HOWARD COUNTY HISTORIC PRESERVATION COMMISSION

Agenda

Thursday, August 1, 2019; 7:00 p.m.

HPC-19-40 and HPC-19-41 – 3709-3713 Old Columbia Pike

Figure 5 - Proposed black metal fencing

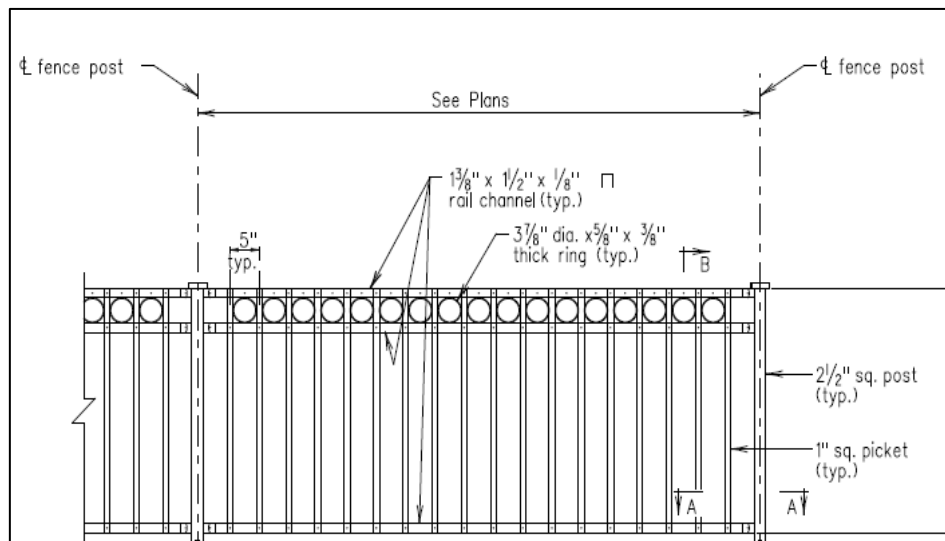
The fence will be located along the top of the culvert, as shown in the elevations in the application. The fence will be located along the stream walls and will also be located along the slope adjacent to part of the new pathway, as shown in the site plan. The fence will be a black metal fence, with the "O" detail. The fence will be 3 feet high, with 2 ½ inch square posts and 1-inch square pickets.

- 4) *Chapter 9.D recommends, "install open fencing, generally not more than five feet high, of wood or dark metal."*

The use of the proposed black aluminum fencing and railing complies with Chapter 9 recommendations as referenced above in bullets #2, 3 and 4. The fencing will match other fencing used on County property throughout the district and is also a black metal that is open and not more than five feet high.

Staff Recommendation to the HPC: Staff recommends the HPC approve the application as submitted.
